CALIFORNIA COASTAL COMMISSION

REGULAR CALENDAR
STAFF REPORT AND PRELIMINARY RECOMMENDATION

Application No.: 6-04-38

Site: 703 & 705 Zanzibar Court, Mission Beach, San Diego, San Diego County.
APN 423-314-01

Looking south along public boardwalk (Ocean Front Walk)

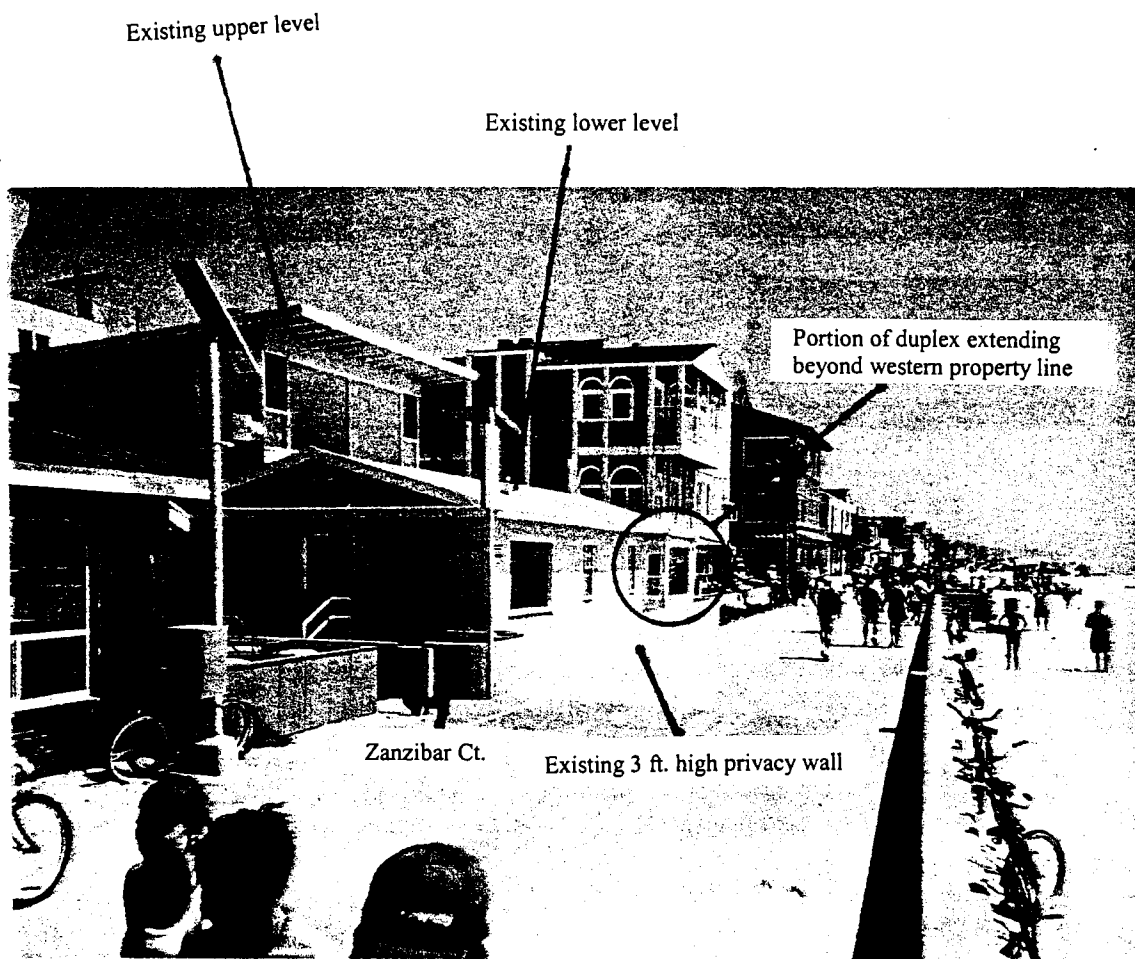
I have not seen the building plans. But the current building has part of the building on a zero lot line next to the boardwalk. It is the last ten feet of the building. This part of the structure should not be allowed to stay if there is a major renovation of this building.

The city allowed the homeowners to build ~~th~~ a new wall three feet into the public right away to protect the building in case of wave destruction. As you can see the building north and south wall are back the three feet. Also the remaining house is only 18' from the

boardwalk right of way.

If the owner are doing major work on the second floor, they will not be allowed to build using the current 0 yard setback or 18 inch setback.

Thus they will have major work on the first floor for support on the second or third floor. The building should be move back three feet from property line, so the current wall can be moved back ^{three feet}. Bring back the ^{total} boardwalk access, the city backed down by allowing the homeowners to come into the boardwalk right-of-way. They will never take that wall down if the Coastal Commission doesn't enforce the right of way.

You can tell something is wrong, when the city allowed the new wall to be three feet into right of way even though most of the wall is back 18 inches. Thus they have a four and half space. Politics, the planning group voted ^(2 years ago) unanimous that if most of the building is not on the zero lot line the ^{new} wall should not be into three foot setback except for portion that is zero. The city sent out Terri Williams and another person. They ignored our vote.
